# Submissions Report

SSD 79658964  
Build-to-rent housing and mixed-use development  
270 Pacific Highway, Crows Nest

Prepared for Silvernight

Figure 1: Current Scheme (Source: Fitzpatrick Partners)

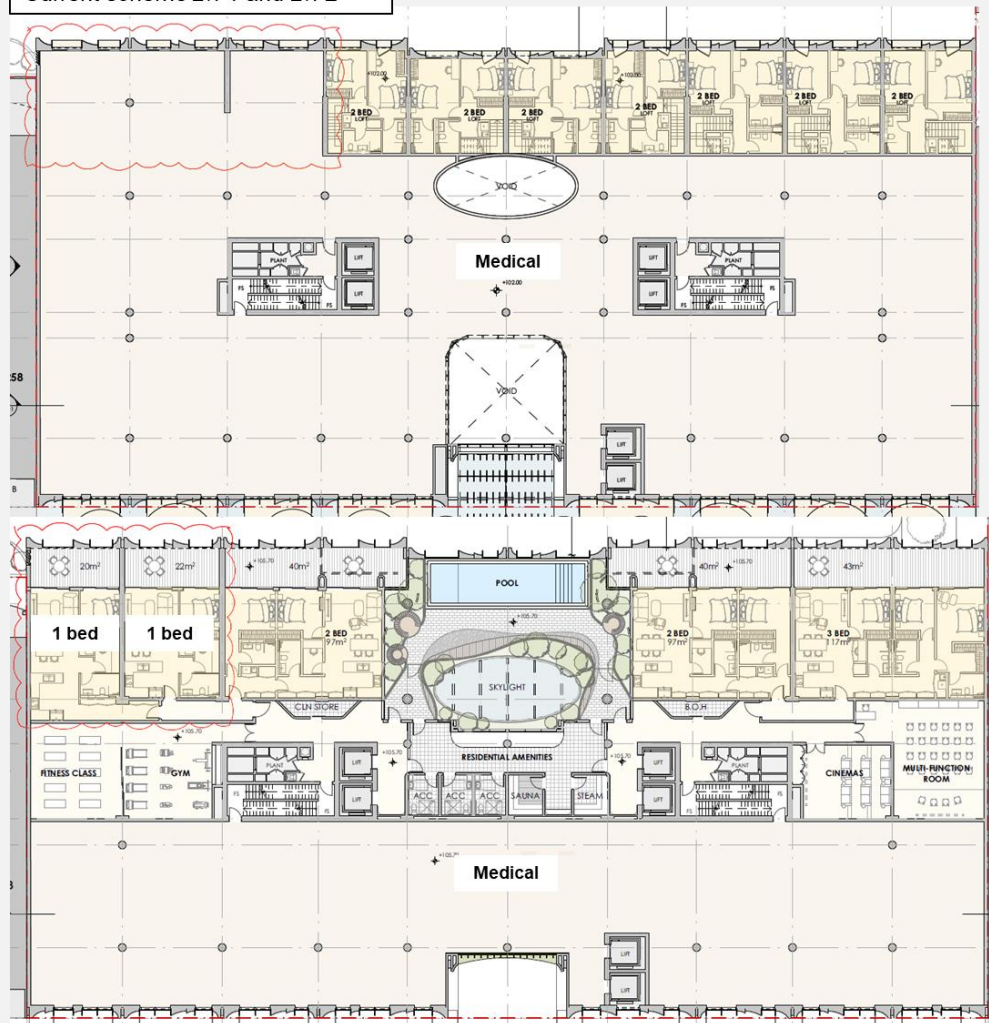
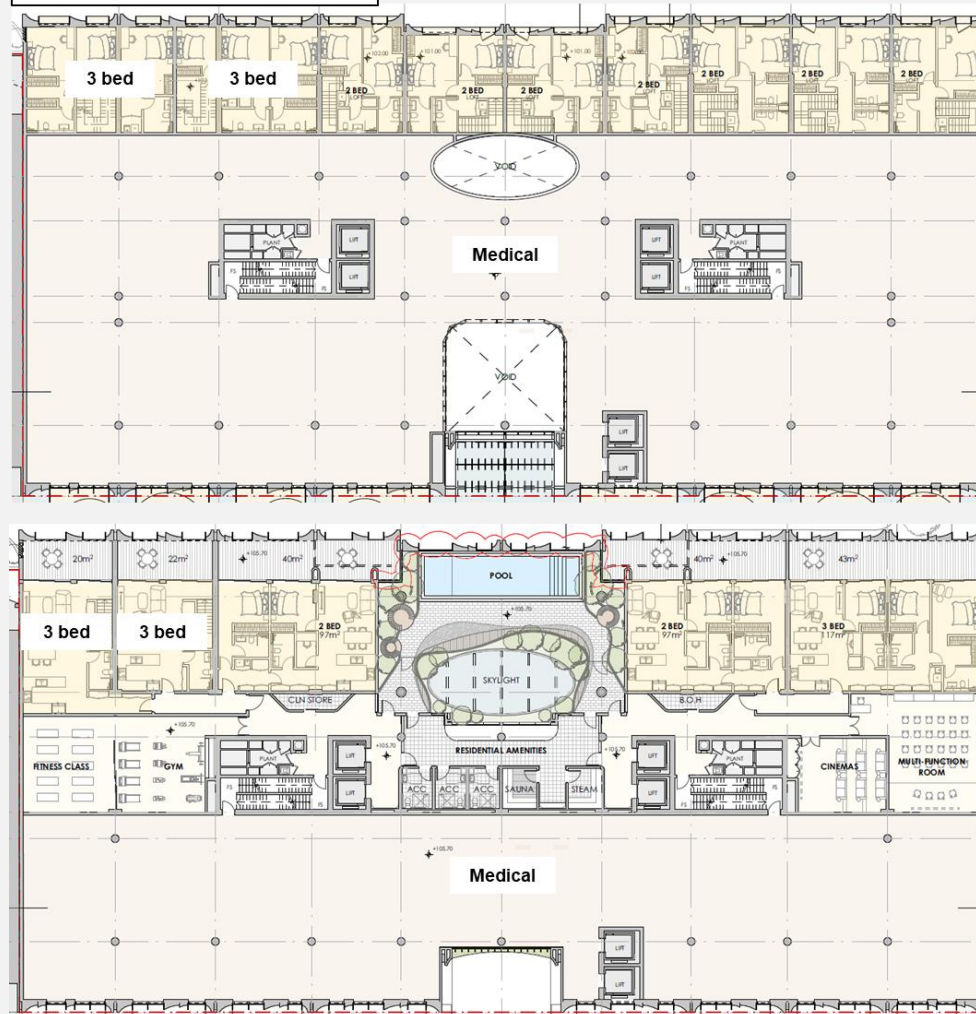
| Ref. | Summary of submission                                                                                                                                                                                                                                                                                                                                                                                                                                                                                     | Response                                                                                                                                                                                                                                                                                                                                                                                                                                                                                                                                                                                                                                                                                                                                                                                                                                                                                                                                                                                                                                                                                                                                                                                                                                                                                |
|------|-----------------------------------------------------------------------------------------------------------------------------------------------------------------------------------------------------------------------------------------------------------------------------------------------------------------------------------------------------------------------------------------------------------------------------------------------------------------------------------------------------------|-----------------------------------------------------------------------------------------------------------------------------------------------------------------------------------------------------------------------------------------------------------------------------------------------------------------------------------------------------------------------------------------------------------------------------------------------------------------------------------------------------------------------------------------------------------------------------------------------------------------------------------------------------------------------------------------------------------------------------------------------------------------------------------------------------------------------------------------------------------------------------------------------------------------------------------------------------------------------------------------------------------------------------------------------------------------------------------------------------------------------------------------------------------------------------------------------------------------------------------------------------------------------------------------|
|      | <p><i>Based on a site area of 3,796m<sup>2</sup>, the proposed development provides a non-residential FSR of 0.95:1 (3,593m<sup>2</sup> GFA) and does not meet the 1:1 non-residential FSR proposed in the concurrent rezoning. The development is required to be amended to ensure compliance with the proposed 1:1 non-residential FSR (or revised non-residential FSR based on item 1).</i></p>                                                                                                        | <ul style="list-style-type: none"> <li>The Architectural Plans (Appendix 2) have been amended to increase the non-residential Gross Floor Area (GFA) to 3,831m<sup>2</sup>, which achieves a non-residential FSR of 1:1.</li> <li>Specifically, Level 1 has been modified to increase the GFA of the medical centre by 58m<sup>2</sup>. As shown in the figures below, this has resulted in: <ul style="list-style-type: none"> <li>the removal of the split level two 3 bedroom units from the southern corner of Level 1 and replacement with medical centre GFA (see extract below) and</li> <li>changing the dwellings above on Level 2 from 3 bedroom dwellings to 1 bedroom dwellings (see extract below)</li> <li>an addition of a non-residential bike parking space</li> <li>changing 2 courier car parking spaces to 2 medical spaces</li> </ul> </li> </ul>                                                                                                                                                                                                                                                                                                                                                                                                                  |

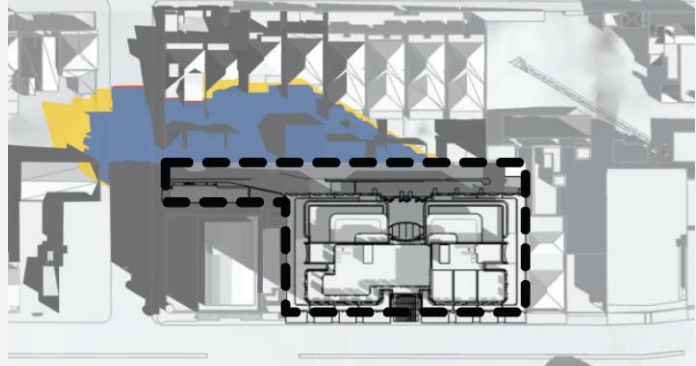
| Ref. | Summary of submission                                                                                                                                                                                                                                                                                                                                                                                                                                                                                                                                                                                                                                                                                                                            | Submitter                                             | Response                                                                                                     |
|------|--------------------------------------------------------------------------------------------------------------------------------------------------------------------------------------------------------------------------------------------------------------------------------------------------------------------------------------------------------------------------------------------------------------------------------------------------------------------------------------------------------------------------------------------------------------------------------------------------------------------------------------------------------------------------------------------------------------------------------------------------|-------------------------------------------------------|--------------------------------------------------------------------------------------------------------------|
| X2   | <b>Recommended Condition</b><br>The following requirement is recommended to be included in any consent issued by DPHI: <ul style="list-style-type: none"><li>A Road Occupancy License (ROL) shall be obtained from the Transport Management Centre for any works that may impact on traffic flows on Pacific Highway during construction activities. A ROL can be obtained through <a href="https://myrta.com/oplinc2/pages/security/oplincLogin.jsf">https://myrta.com/oplinc2/pages/security/oplincLogin.jsf</a>.</li></ul>                                                                                                                                                                                                                    | <ul style="list-style-type: none"><li>TfNSW</li></ul> |                                                                                                              |
